REFERENCE NUMBER: HMT-0102-00-E

SUBJECT: Recall #32 P Series Operator's Manual v3.1, Manual Storage, Capacity Chart and Wall Tie Chart stickers

To: Distributor Network
Cc: Regional Managers & Marketing Department
From: R&D and Engineering Department
Date: December 19th-2005
No : Recall #32
Re: **P Series Operator's Manual v3.1, Manual Storage, Capacity Chart and Wall Tie Chart stickers**

Subject: **Second notice for P Series Operator's Manual v3.1, Manual Storage, Capacity Chart and Wall Tie Chart stickers**

Hydro-Mobile logo on outside of guardrail

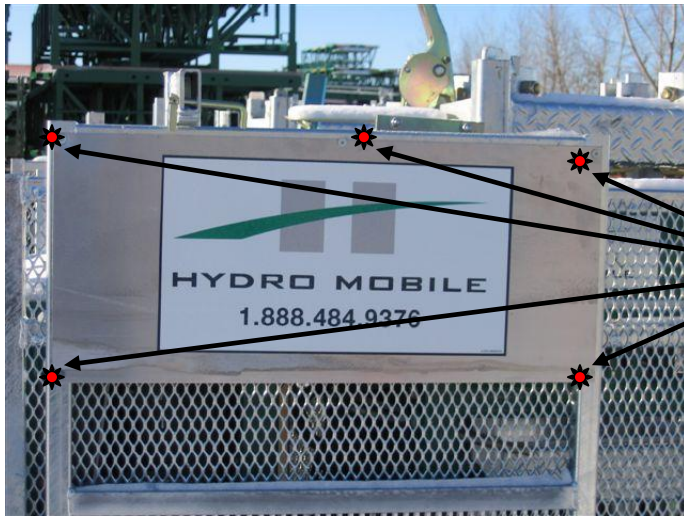
Installation procedure for the aluminum panel (capacity chart sticker):

The plate will have to be bolted on by the customer on the back guardrail of the P Series extension platform. Install the aluminum plate outside of the guardrail as shown hereafter with 5x self-tapping screws. The plate must be installed so the chart is facing inward and the Hydro Mobile logo facing outward.

Self-Tapping screws

Procedure for the installation of version 2 of the wall tie schedule sticker

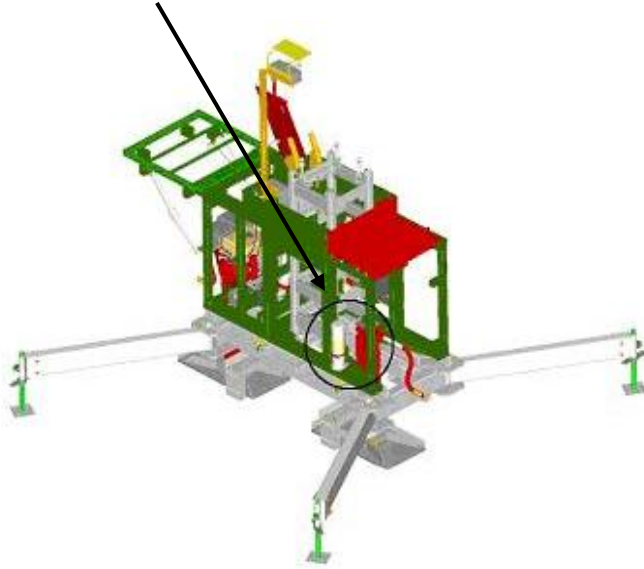
On P Series motorized units already equipped with an aluminum panel, paste the new version #2 wall tie schedule sticker on top of the old one.

Location of toolbox on power unit

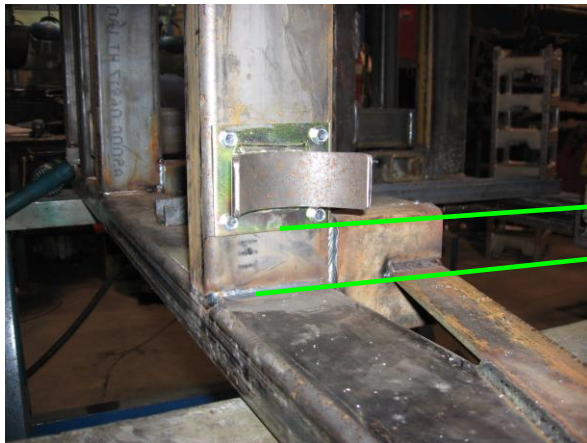
Procedure for the installation of the Operator's manual storage container :

The Operator's manual storage container attachment bracket will have to be mounted on the 4x2 rectangular tube as shown on the picture below with 4 self-tapping screws. Then, use the clamp to

fix the container in place. Replace any older version of the manual with version 3.1 of the Operator's manual. Recuperate old version of Operator's manual.

Position Toolbox bracket 1 1/2" from the bottom tube and fasten using 4 self tapping screw supplied.

Install Toolbox tube on bracket using hose clamp

Hydro Mobile logo on outside of guardrail

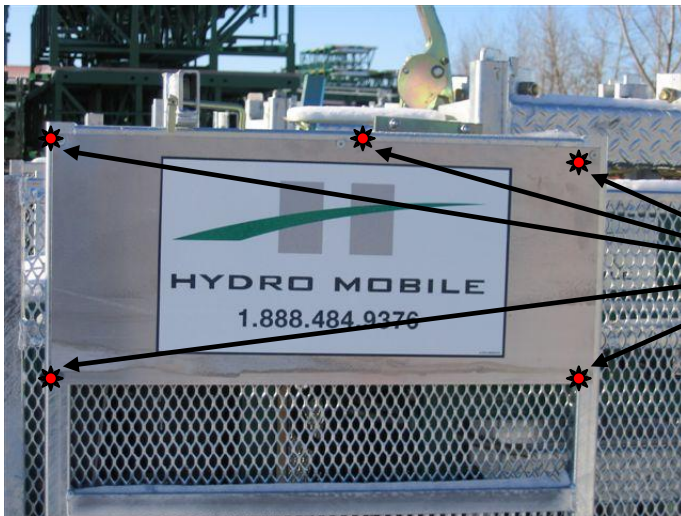
Installation procedure for the aluminum panel (capacity chart sticker):

The plate will have to be bolted on the back guardrail of the P Series extension platform. Install the aluminum plate outside of the guardrail as shown hereafter with 5x self-tapping screws. The plate must be installed so the chart is facing inward and the Hydro Mobile logo facing outward.

Self-tapping screws

Procedure for the installation of version 2 of the wall tie schedule sticker

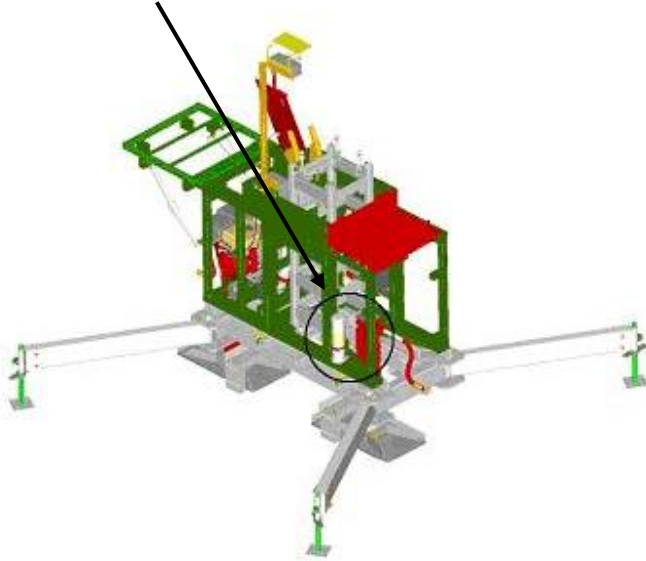
On P Series motorized units already equipped with an aluminum panel, paste the new version #2 wall tie schedule sticker on top of the old one.

Location of manual storage container on motorized unit

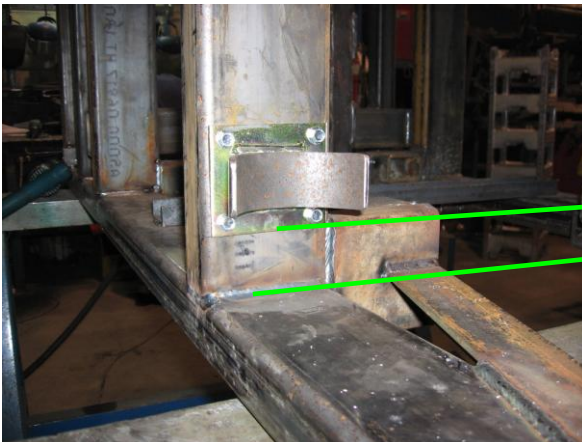
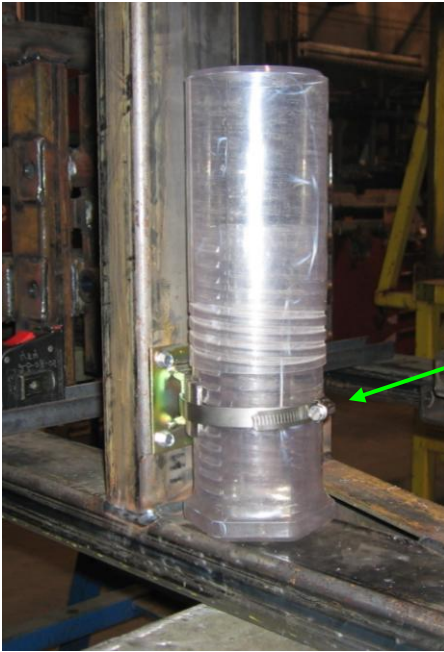
Procedure for the installation of the Operator's manual storage container-:

The Operator's manual storage container attachment bracket will have to be mounted on the 4x2 rectangular tube as shown on the picture below with 4 self-tapping screws. Then, use the clamp to fix the container in place. Replace any older version of the manual with version 3.1 of the Operator's manual. Recuperate old version of Operator's manual.

| Position manual storage container bracket -1 1/2" from bottom tube and fasten using 4 self tapping screws supplied.

Install manual storage container on bracket using hose clamp
